# Design Review Board

## *Meeting Minutes*

- 3b DRB25-00686 "Redhawk - Phase 3"** 187± acres located at the northwest corner of South Sossaman Road and East Elliot Road. Design Review of a Data Center. **(District 6)**

## Red Hawk Phase 3

# Landscape Plan

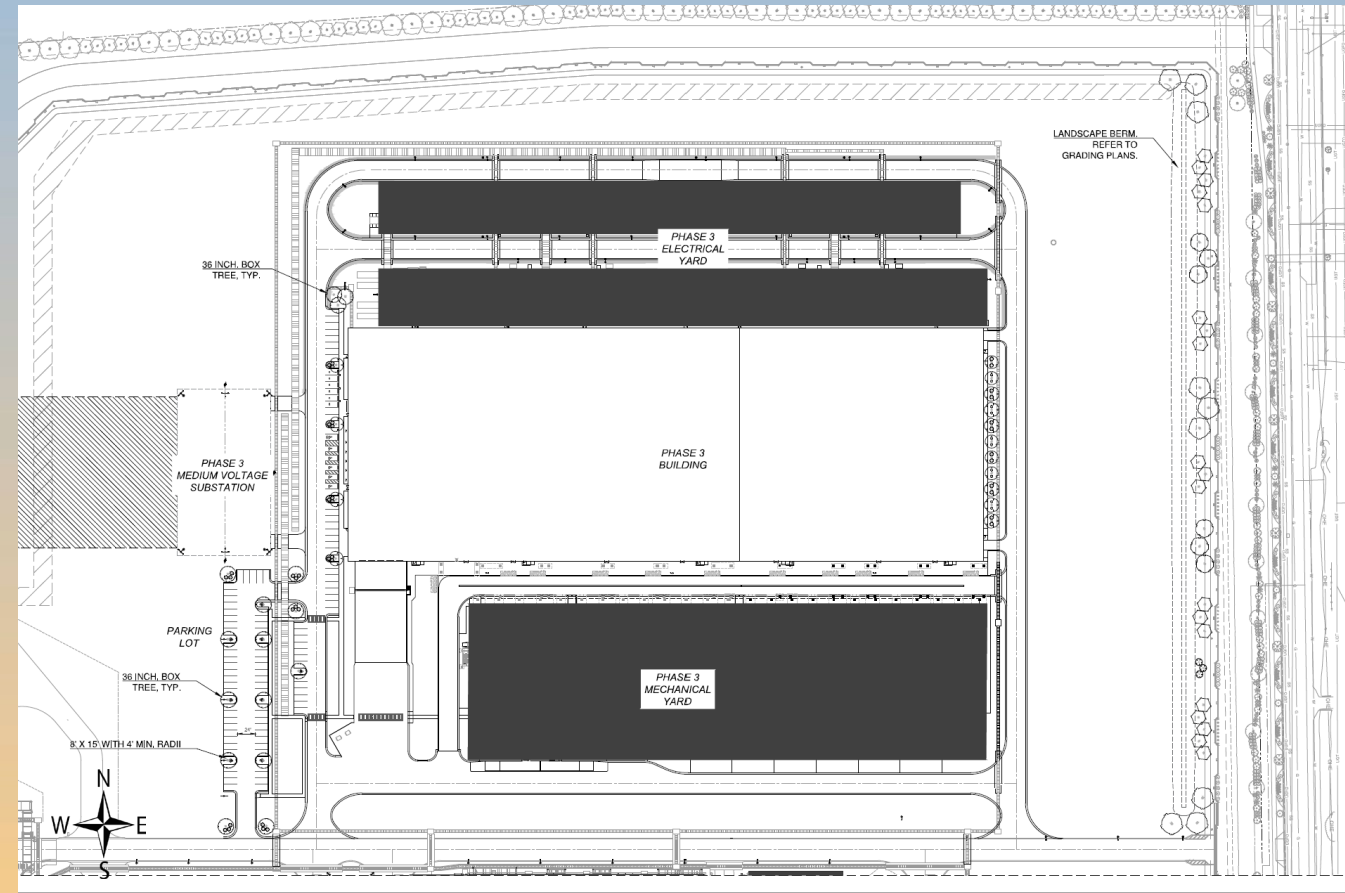
- Replace the Chrysactinia Mexicana "Damianita" shrubs with a hardier shrub better suited for the Arizona environment.
- Add trees and shrubs to the median area located to the south of the Phase 3 mechanical yard.
